THIRD READINGS SUMMARY SHEET

CASE: C814-2023-0057 (200 E. Riverside PUD) DISTRICT: 9

ZONING CHANGE REVIEW SHEET

CASE: C814-2023-0057 (200 E. Riverside PUD) DISTRICT AREA: 9

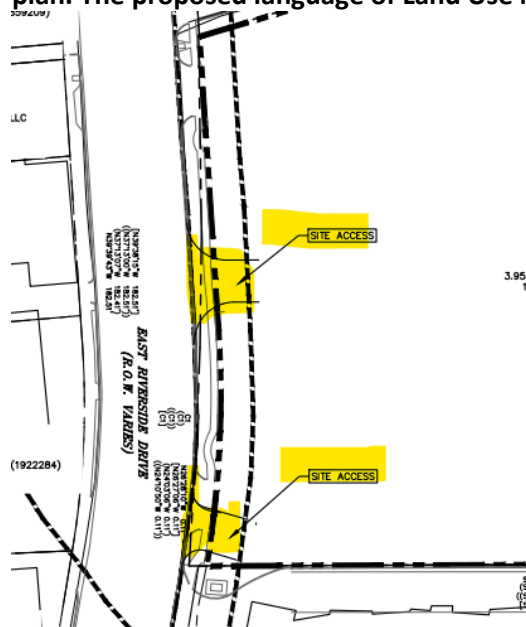
U2: Comment pending. The TIA final memo states the following:

8. Approval of this TIA does not grant nor guarantee approval of proposed driveway locations or driveway types. An updated TIA or addendum may be required at the time of the site plan when more details about the site are available.

Accordingly, please remove any reference to site access points from the PUD exhibits or note that they are only demonstrative and subject to review at the time of site plan. The proposed language of Land Use Note #1 should be modified to reflect this.

Figure 2: Barton Springs Road Extension Cross Sections

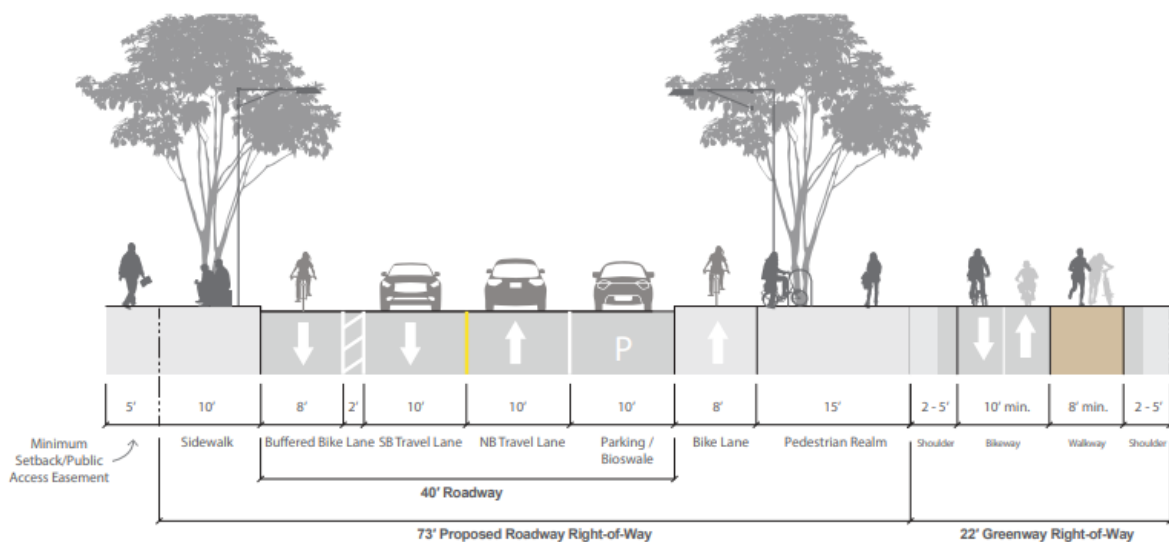
TPW recommends that the PUD specify these improvements by offering deference to the South Central Waterfront Plan, specifically the 22' "greenway" and/or the desired cross-section as identified by Project Connect when available:

- U1: Comment pending TPW comment #6.
- U2: **Comment pending. Land Use Note #24-** at this time it is unclear how these “improvements” will be above and beyond the base line requirements of the TCM. Please clarify what these improvements may entail and add the language “subject to approval from Director” to the proposed note.
